# MONITORING YEAR 6 ANNUAL REPORT

## MOORES FORK STREAM MITIGATION PROJECT

RE: Moores Fork Stream Mitigation Project  
Yadkin River Basin – CU# 03040101  
Surry County, North Carolina  
NCEEP Project # 94709  
Contract No. 6500

Wildlands Engineering, Inc. (Wildlands) has reviewed the Division of Mitigation Services (DMS) comments from the Draft Monitoring Year 6 report for the Moores Fork Stream Mitigation Project. The following Wildlands responses to DMS's report comments are noted in italics lettering.

Figure 3.3 Current Condition Plan View (Sheet 3 of 6)  
 Moores Fork Stream Mitigation Project  
 DMS Project No. 94709  
 Monitoring Year 6 - 2021  
 Surry County, NC

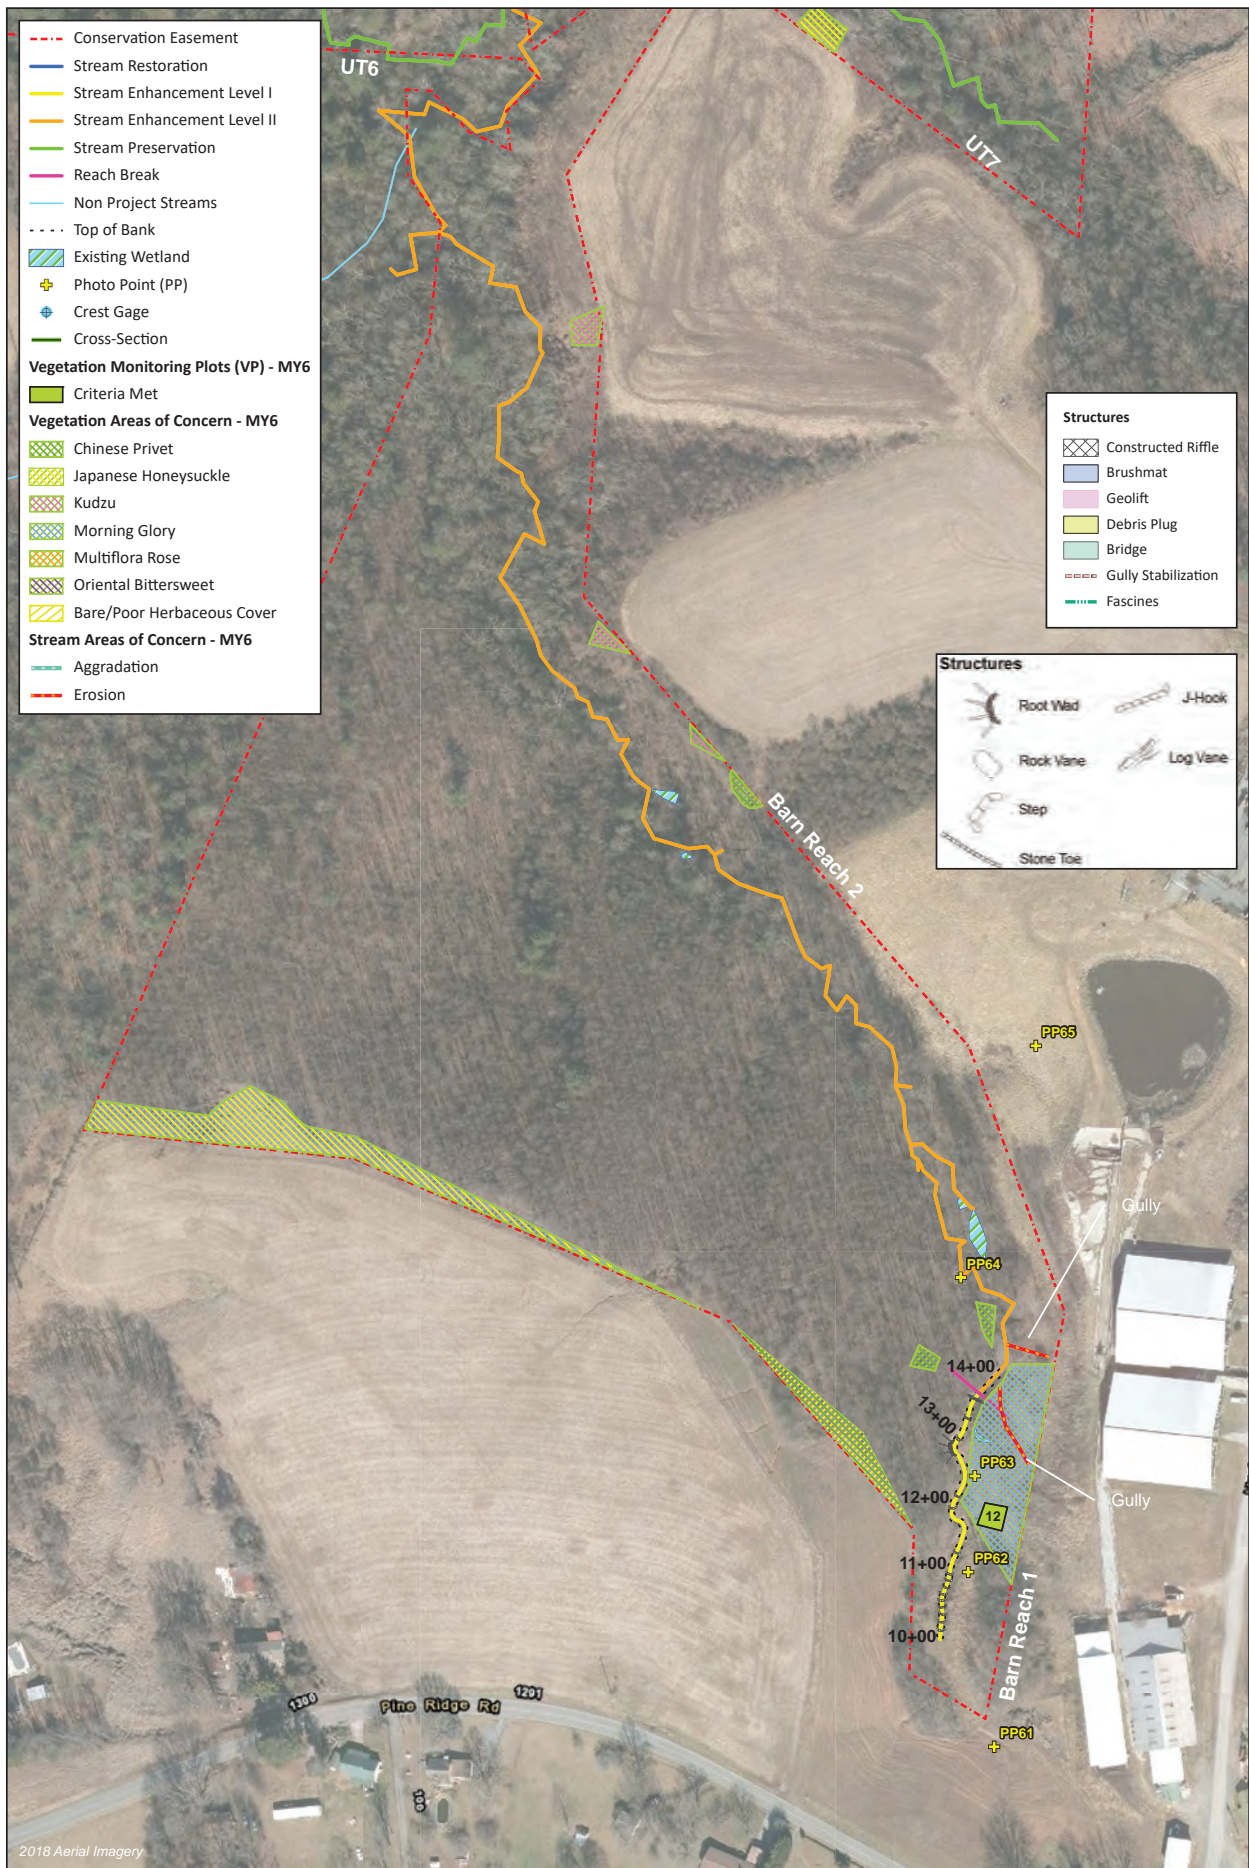
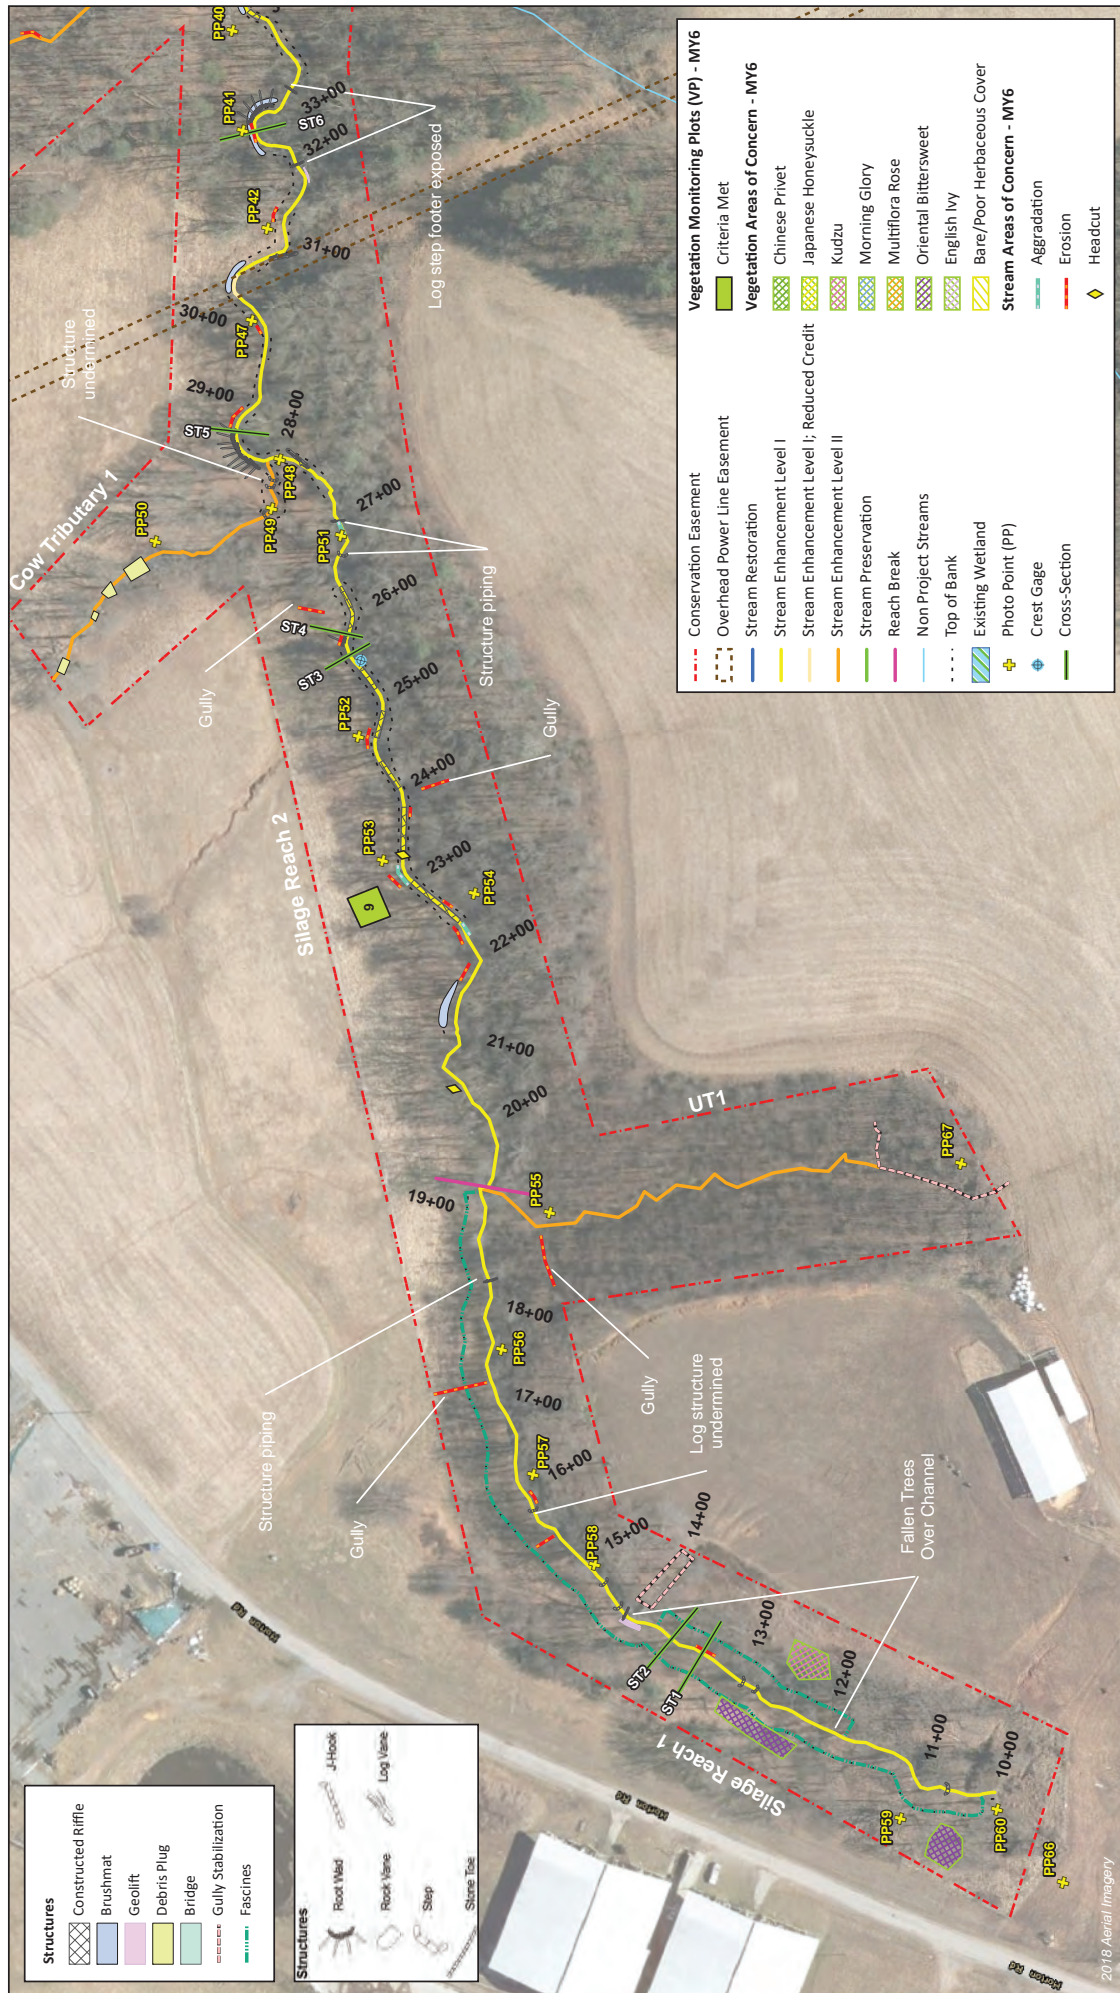
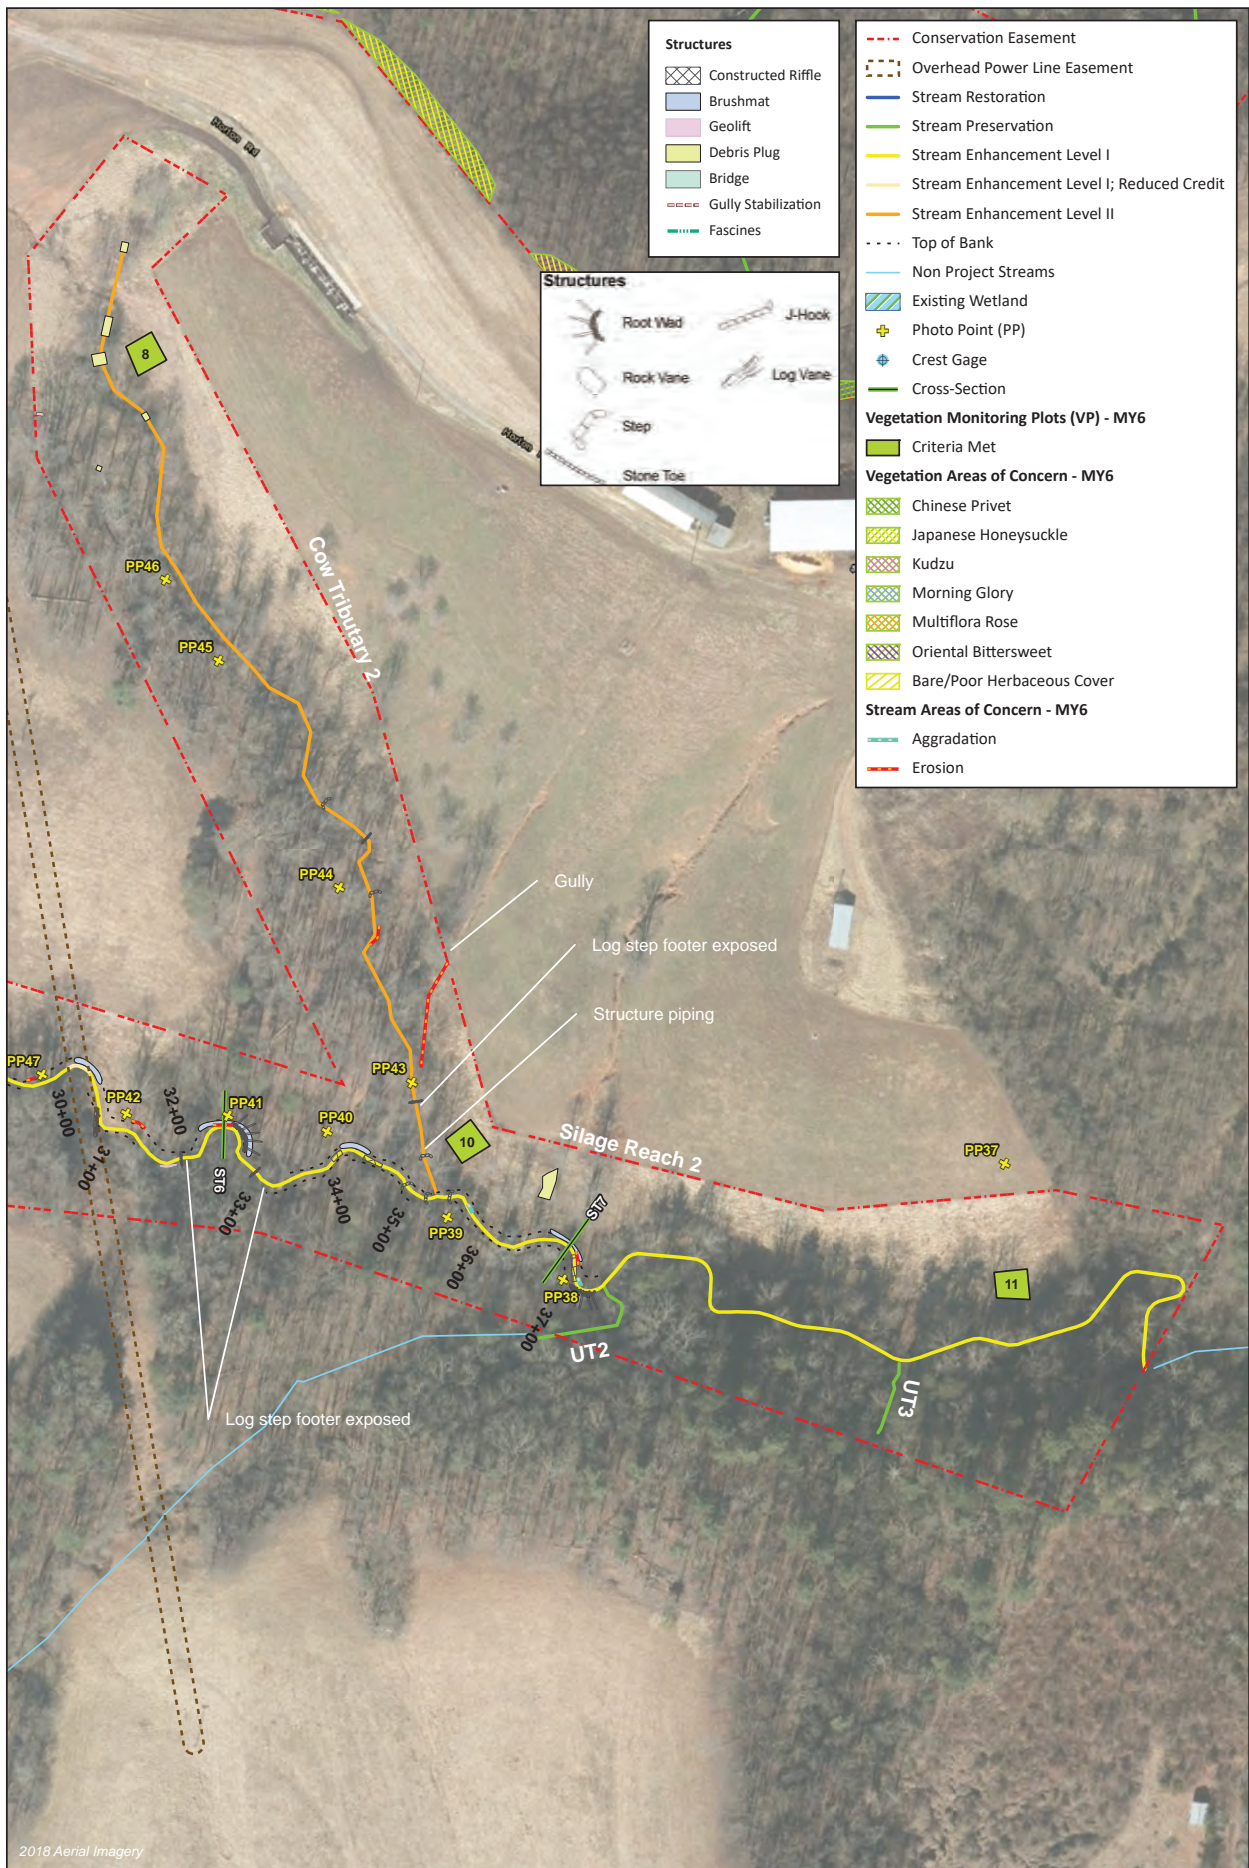
**DMS comment: CCPV: Thanks for providing updated invasive species polygons. Please continue to update as treatment occurs and populations are reduced. This map is a useful tool for the contractor treating the site. DMS will continue treating invasives until the project is closed.**

*Wildlands response: You're welcome. Wildlands will continue to update the CCPV figures as treatment of invasive species occurs, and populations are reduced.*
